PRO DEO Lots 9 & 10, Southview Heights Preliminary Development Plan

Project: Pro Deo Youth Ctr
Issue Date: December 6, 2023

OVERALL SITE PLAN
Preliminary Plans for:
Lot 9 & 10, Southview Heights
Lee's Summit, Jackson County, Missouri

REV. 1/5/2024

LANDSCAPE PLAN

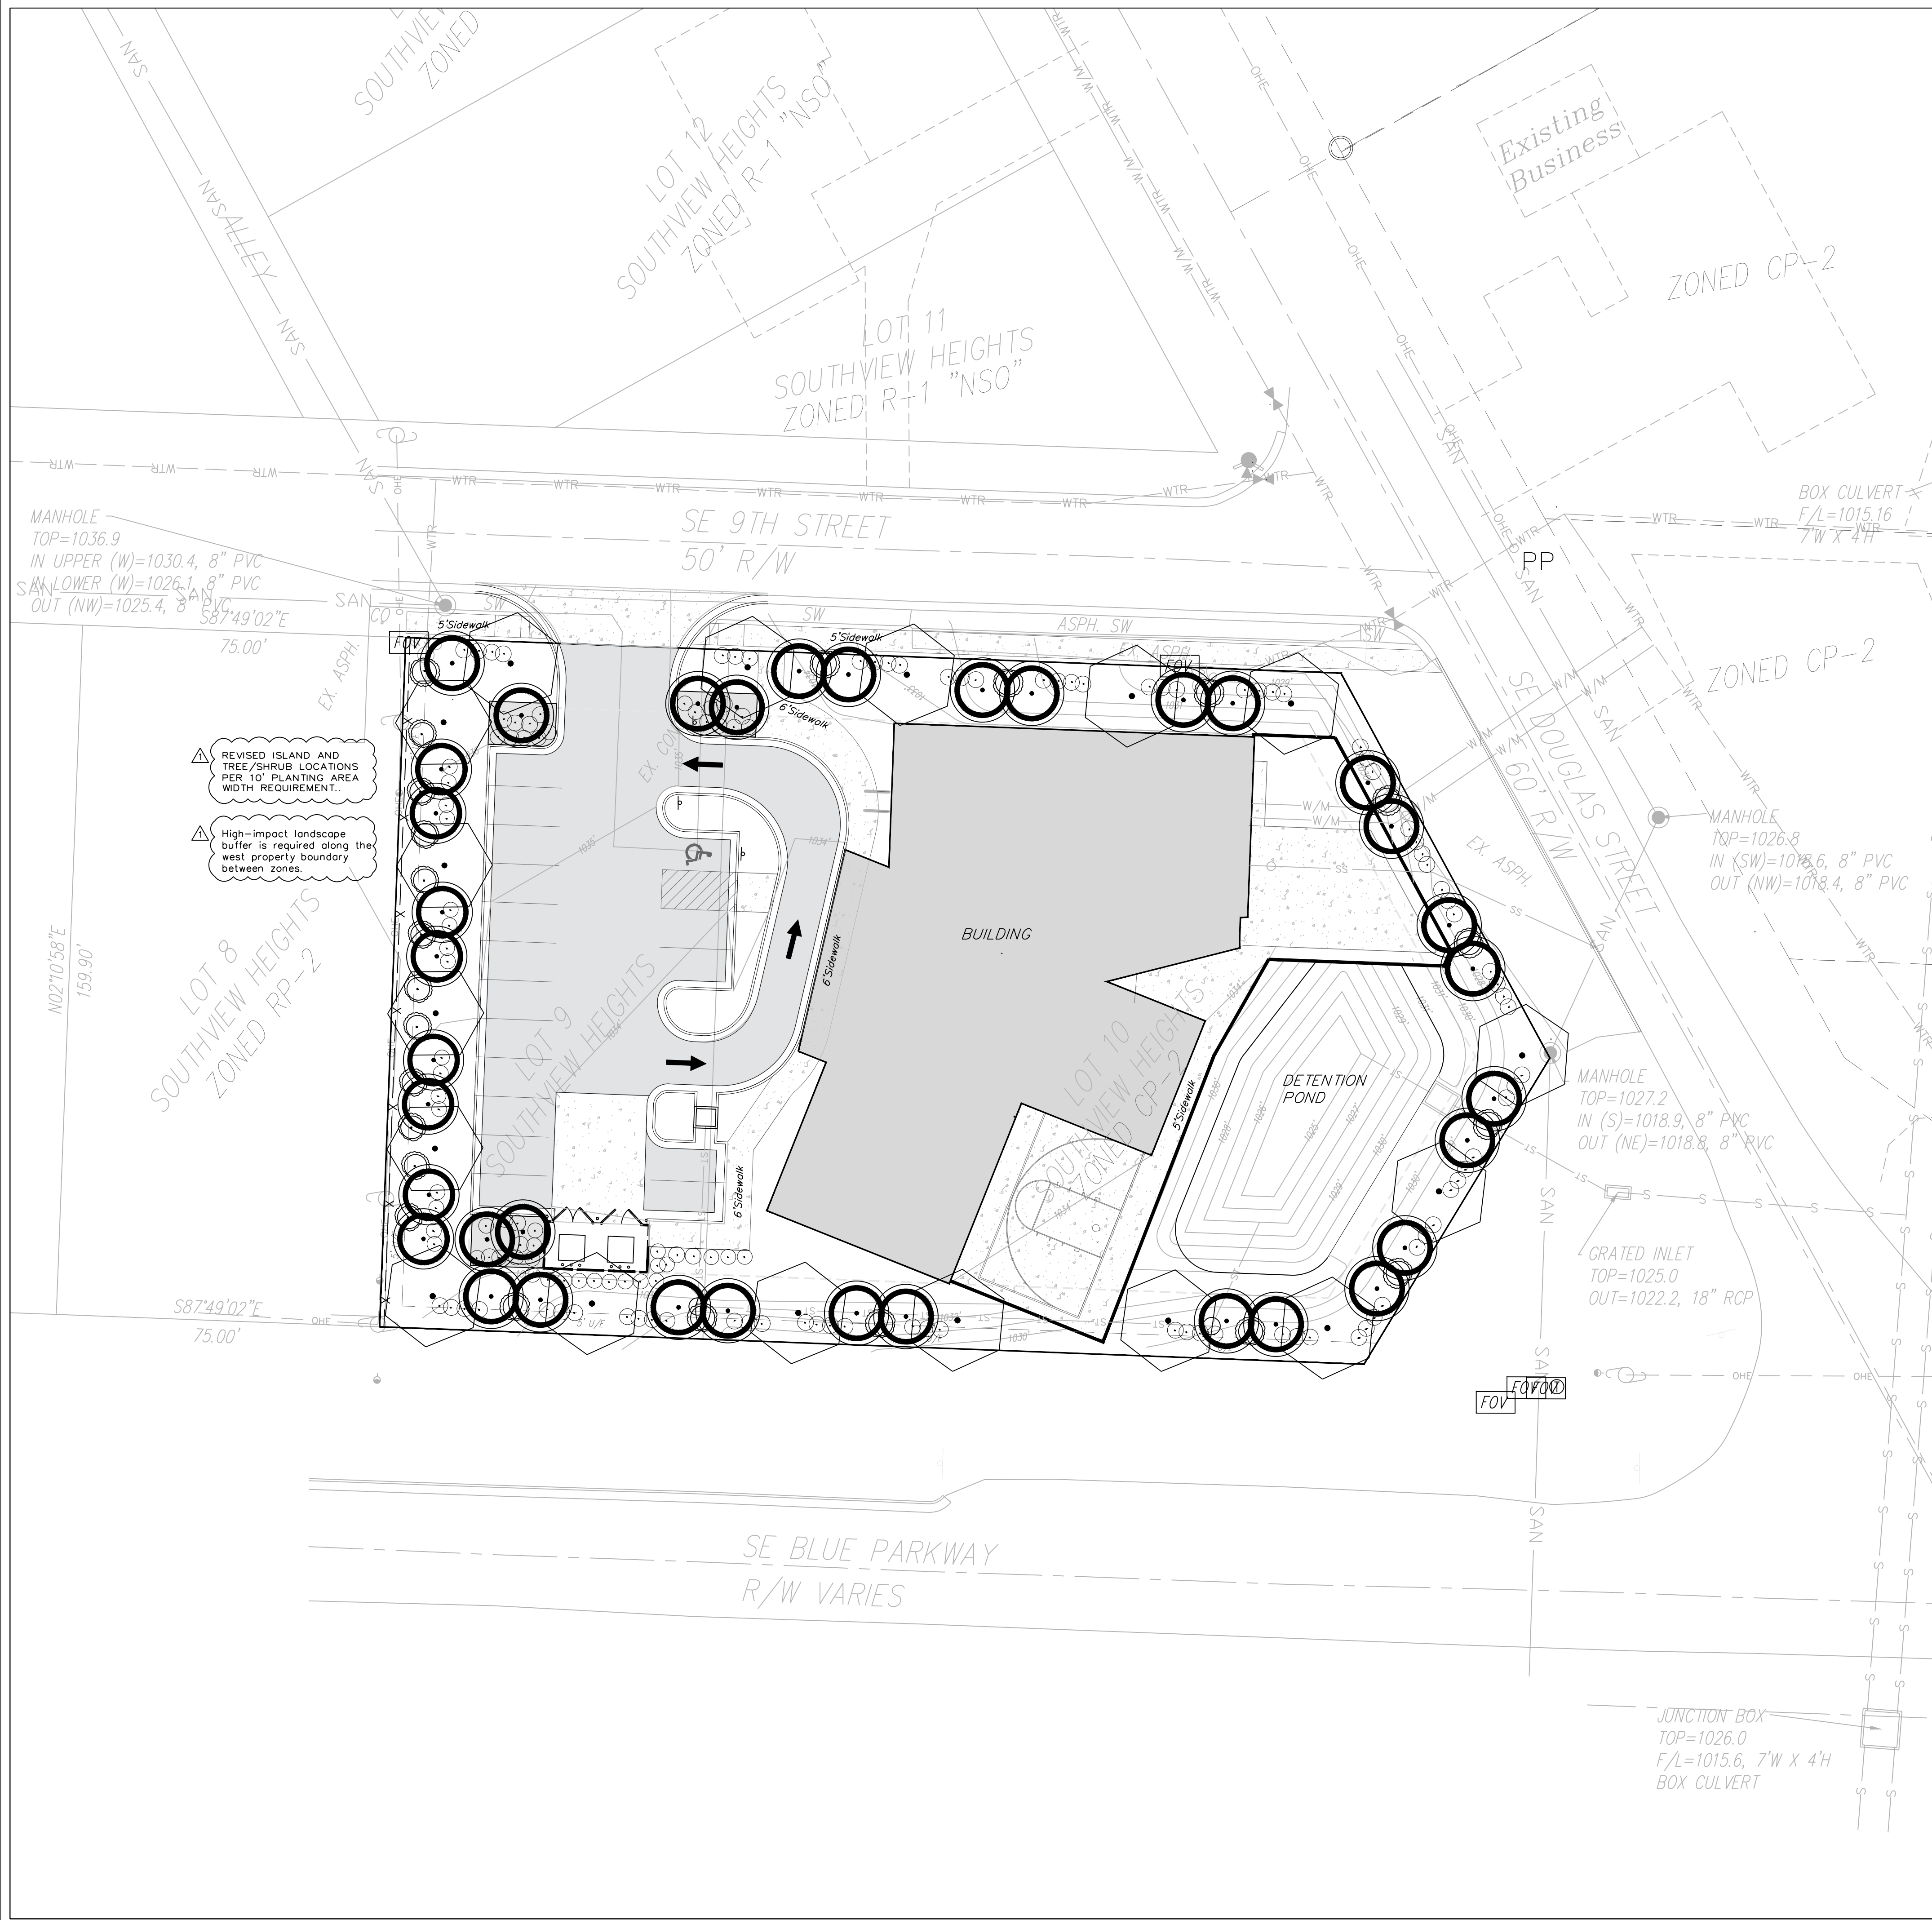
REVISED SCALE.

ADDED GROUND MOUNTED EQUIPMENT NOTE.

SCALE: 1" = 20'

Note:
All Ground mounted equipment shall be totally screened.
